Geotechnical Engineering and Geologic Hazards Study for the Cole Campus Central Administrative Center

Consolidated Engineering Laboratories, as revised September 25, 2020

Subject: ***Response to CGS Review Comments***
Cole Campus – Central Administrative Center
1011 Union Street, Oakland, California 94607
CEL Project No. 84-04726-B

References: 1) *“Geotechnical Engineering and Geologic Hazards Study, Cole Campus – Central Administrative Center,”* CEL Project No. 84-04726-PWA, dated May 22, 2020.
2) *“Engineering Geology and Seismology Review for Central Administrative Center at Cole Campus – New Buildings, CGS Application No. 01-CGS4511,”* dated September 10, 2020.

OUSD - Cole Campus Site Specific Response Spectra

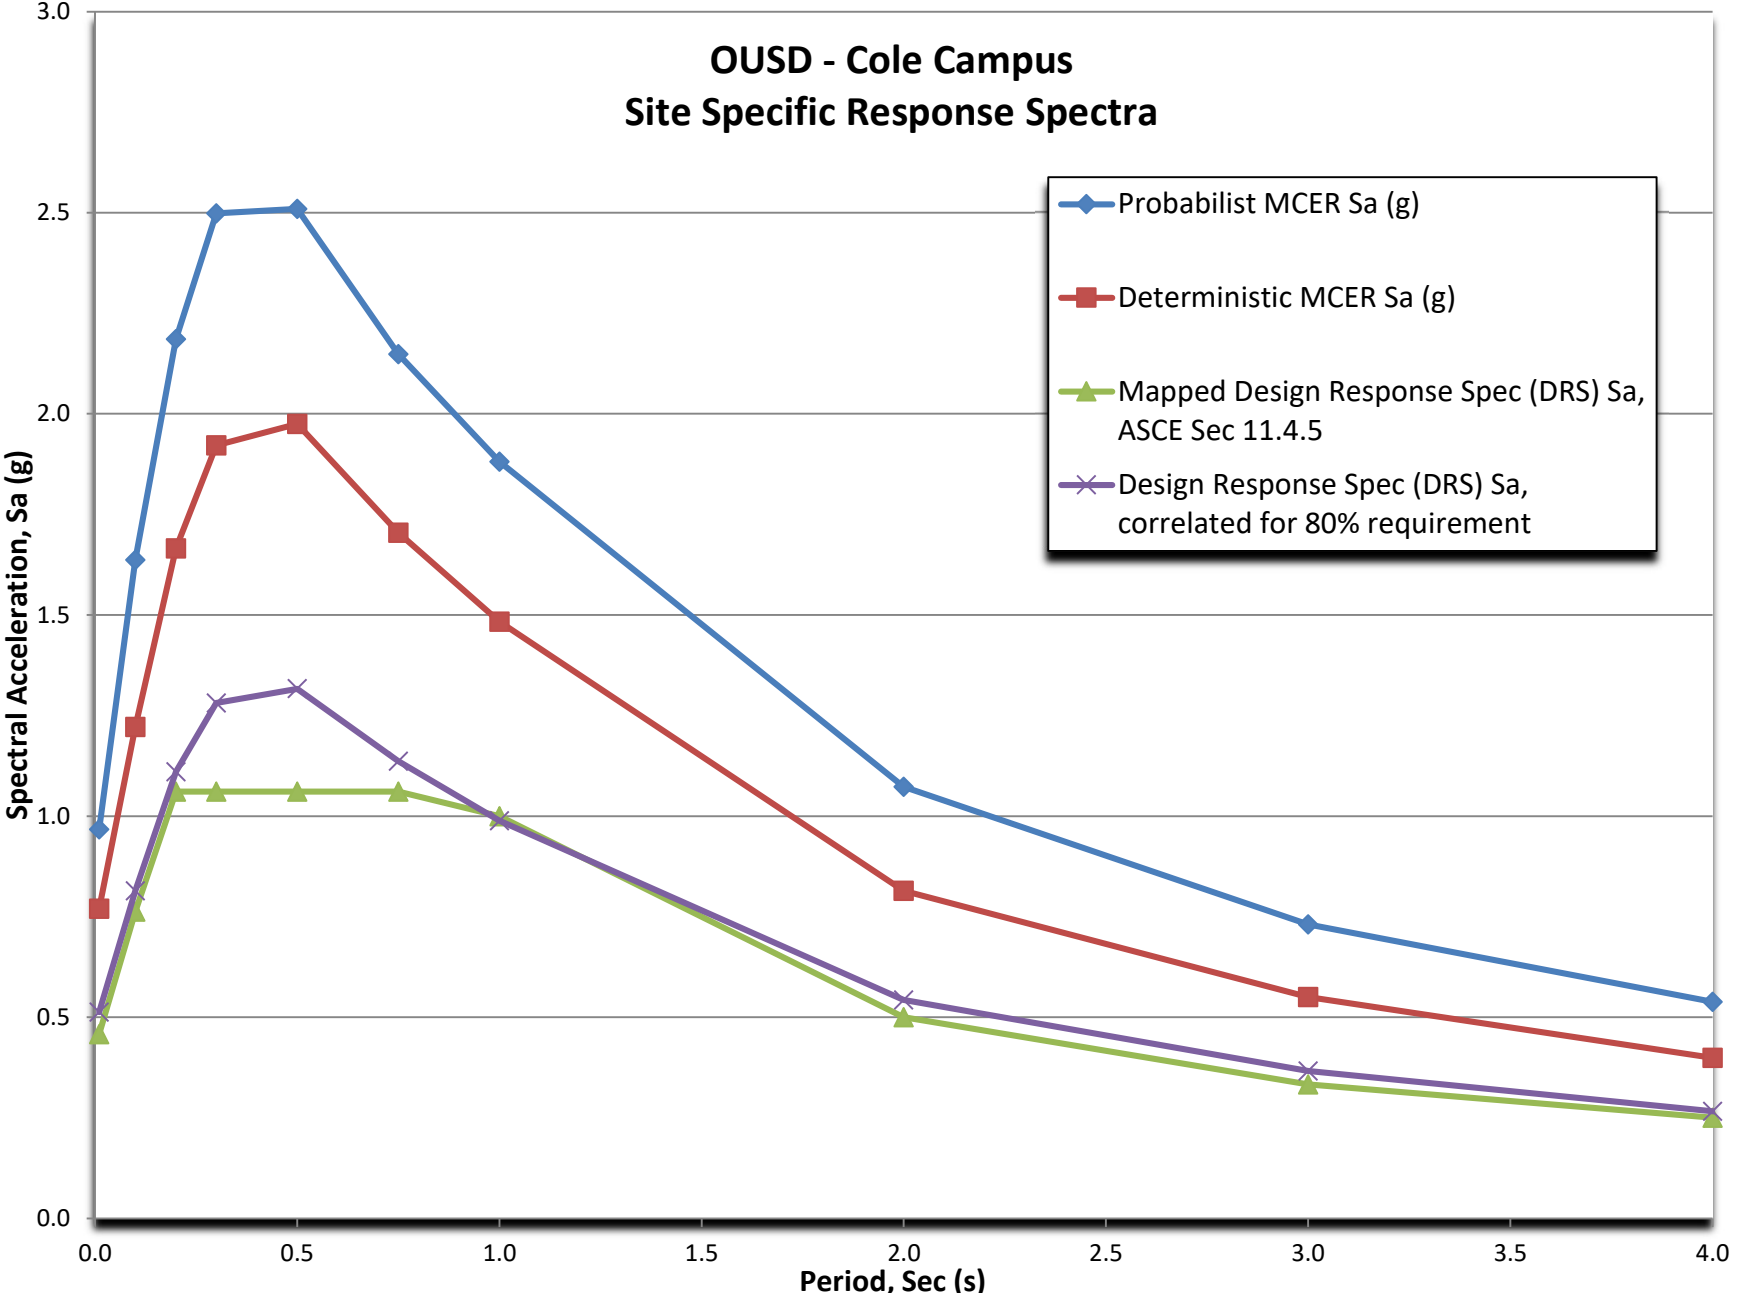
Following their review of our report, CGS (Reference 2) requested CEL revise our site-specific ground motion analysis to include the possibility of rupture of all the segments of the Hayward Fault, and provide updated site-specific ground motion parameters, design response spectrum, and PGA_M . Based on the resulting analysis results, CGS also requested CEL to revise the liquefaction analyses, as needed.

However, CGS notes that the consultants have not included the possibility of rupture of all the segments of the Hayward fault together as is considered in the UCERF 3 community fault model, for their deterministic MCE_R spectrum used as input in the site-specific ground motion hazard analysis. The consultants are requested to **revise their site-specific ground motion analysis based on this recommendation and provide updated site-specific ground motion parameters, design response spectrum, and PGA_M** . The consultants are also requested to update their liquefaction analyses with the updated PGA_M , as needed.

results from the National Seismic Hazard Model (from Petersen and others, 2014) but their deterministic MCE spectrum appears low. CGS notes that the consultants used a M 7.2 on the Hayward (North) fault to calculate their deterministic spectrum, **but they should consider the potential for the whole Hayward fault to rupture for this analysis**, as is considered in both UCERF2 and UCERF 3 community fault models. The consultants are requested to revise their site-specific ground motion analysis using the appropriate magnitude for their deterministic spectrum. The consultants should also check whether PGA_M used in their liquefaction analysis is also appropriate and according to ASCE 7-16 Section 21.5.3.

As recommended by CGS, we revised our May 22, 2020 geotechnical engineering and geologic hazards study report, which is attached. As presented in our revised report, Section 6.2.2 *Deterministic (MCE_R) Ground Motions*, our site-specific ground motion analysis was revised to include all segments of the Hayward Fault: HN+HN+HS. The results of the analysis are presented in Section 6.2 of our revised report.
